## Comment Set E.10: Applicant – Forest Management

## ANTELOPE-PARDEE 500kV TRANSMISSION PROJECT SCE COMMENTS & SUGGESTED REVISIONS ON DEIR/DEIS C.7 FOREST MANAGEMENT ACTIVITIES

## **Response to Comment Set E.10: Applicant – Forest Management Activities**

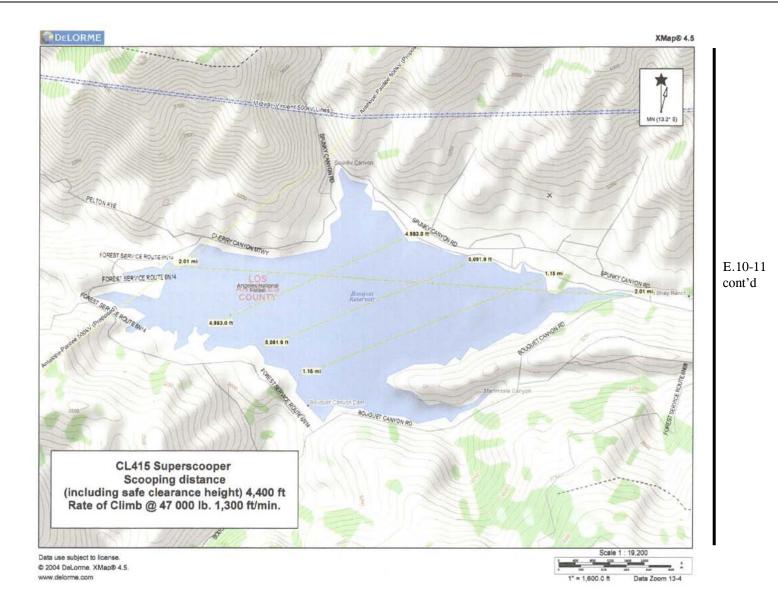
11	C.7.5 Impact F-5: The Project would limit the ability of fixed-wing aircraft to fill up water tanks for aerial drops.	C.17-4	Paragraph 1, Line 3	The DEIR/DEIS states that "The height of the new towers would increase the risk of collision and potentially restrict the use of these aircraft". The document is referring to the use of the fixed-wing "Super Scooper".	SCE is providing the attached Figure which displays the fact that there would be multiple safe flight paths for the "Super Scooper" given its scooping distance and climb rate. The DEIR/DEIS should be revised to include this updated information.	E.10-1

- E.10-11 Although the flight paths provided in the attached map for "Super Scooper" may be safe approaches to Bouquet Canyon Reservoir from the perspective of the transmission lines, during a wildfire there is no guarantee that any of these approaches may be safe with respect to the location of the wildfire. The height and location of the new towers would still restrict the use of "Super Scooper" aircraft and increase their potential for aerial collision. No changes will be made to the analysis or mitigation.
